AMENDMENTS TO THE DRAWINGS

This paper is responsive to the Non-Final Office Action dated August 26, 2004. Claims 1-28 were examined. The drawings are objected to under 37 C.F.R. § 1.83(a). Claims 9, 16-18, 25, and 26 are objected to under 35 U.S.C. § 112, second paragraph. Claims 1-11, 13-15, 18-20, and 23-28 stand rejected under 35 U.S.C. § 102(e) as being anticipated by U.S. Patent No. 6,707,318 to Kumar et al. Claims 12, 21, and 22 stand rejected under 35 U.S.C. § 103(a) as being unpatentable over Kumar in view of U.S. Patent No. 6,542,006 to Sprague et al.

DKT. No. 004-8850

FIG. 4

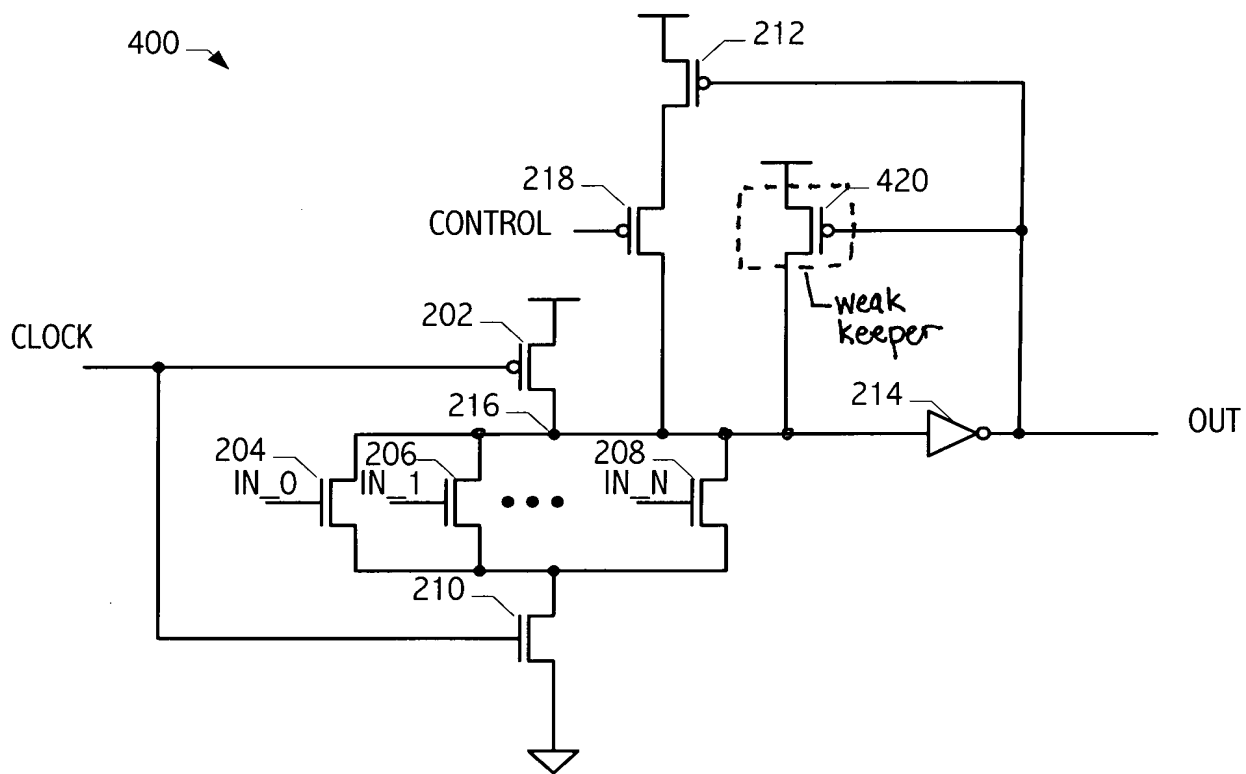
The attached sheet(s) of drawings include changes to Fig. 4 and new Fig. 5 replaces the original sheet(s) including such figures.

The drawings are objected to under 37 C.F.R. § 1.83(a) for failing to show every feature of the invention specified in the claims. Figure 4 has been amended to indicate that weak keeper 420 is a weak keeper. This amendment is supported at least in the specification at page 6, paragraph 1022. No new matter is added. In addition, Figure 4 was amended to clarify the connections between pull-down devices 206 and 208 to dynamic node 216 and to clarify the connection between weak keeper 420 to dynamic node 216. Figure 5 has been added to illustrate that the dynamic node is precharged low and the evaluation circuit is p-logic. Figure 5 is supported at least by paragraph [1026] in the specification as filed on June 27, 2003 and originally filed claims 21 and 22. No new matter is added.
